Access Compliance Report

Public Rights-of-Way

(Curb Ramps)

Intersection ID: 16069	Main Street: BOWMAN_RD	Cross Street: S_TRYON_ST	Location: NW
ADA ID: 30F6805B8016	Ramp Type: PerpDiag	Initial Pass/Fail: Fail	Overall Compliance: No
Severity Score: 10			
Codes/Mitigation Info/Possible Solution		Field Measurements/Component Compliance

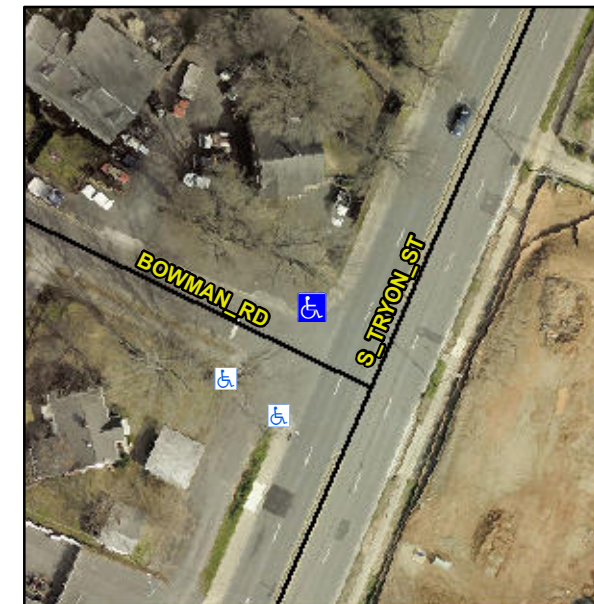
R304.5.1, R304.5.3

Compliance	Description	Data	Compliance	Description	Data
N/A	Ramp Length (in)	72.0	Yes	Ramp Slope (%)	7.7
No	Ramp Width (in)	44.0	No	Ramp XSlope (%)	4.4
N/A	Flare Type LT	N/A	N/A	Flare Type RT	N/A
N/A	Flare Slope LT (%)	N/A	N/A	Flare Slope RT (%)	N/A
N/A	Flare Traversable LT?	N/A	N/A	Flare Traversable RT?	N/A
N/A	Landing Length (in)	N/A	N/A	DWS Provided?	N/A
N/A	Landing Width (in)	N/A	N/A	DWS Contrast?	N/A
N/A	Landing Slope (%)	N/A	N/A	DWS Length (in)	N/A
N/A	Landing X Slope (%)	N/A	N/A	DWS Full Width?	N/A
N/A	Landing Curb? (Y/N)	N/A	N/A	DWS Offset (in)	N/A
N/A	Shared Landing?	N/A			
N/A	Gutter Ponding?	N/A	N/A	Gutter Slope (%)	N/A
N/A	Gutter Lip Ht (in)	N/A	N/A	Gutter X Slope (%)	N/A
N/A	Painted X Walk1?	No	N/A	Painted X Walk2?	No
	X Walk 1 Direction	To SW		X Walk 2 Direction	To SE
N/A	X Walk 1 Width (in)	N/A	N/A	X Walk 2 Width (in)	N/A
	X Walk 1 Slope (%)	5.2		X Walk 2 Slope (%)	5.8
	X Walk 1 X Slope (%)	0.1		X Walk 2 X Slope (%)	6.1

N/A	Ramp inside XWalk1?	N/A	N/A	Ramp inside XWalk2?	N/A
	Road Slope (%)	2.2	N/A	Clear Space?	N/A
	Road X Slope (%)	7.4	N/A	Clear Space to XWalk (in)	N/A
N/A	Any Obstructions?	N/A	N/A	Storm Grate/Utility Hazard?	N/A
	Obstruction Type			Storm Grate/Utility Type	
		N/A			N/A
			Yes	Surface Condition? (G/P)	Good

Remove & Replace Curb Ramp With Two New Directional Ramps or Equivalent.
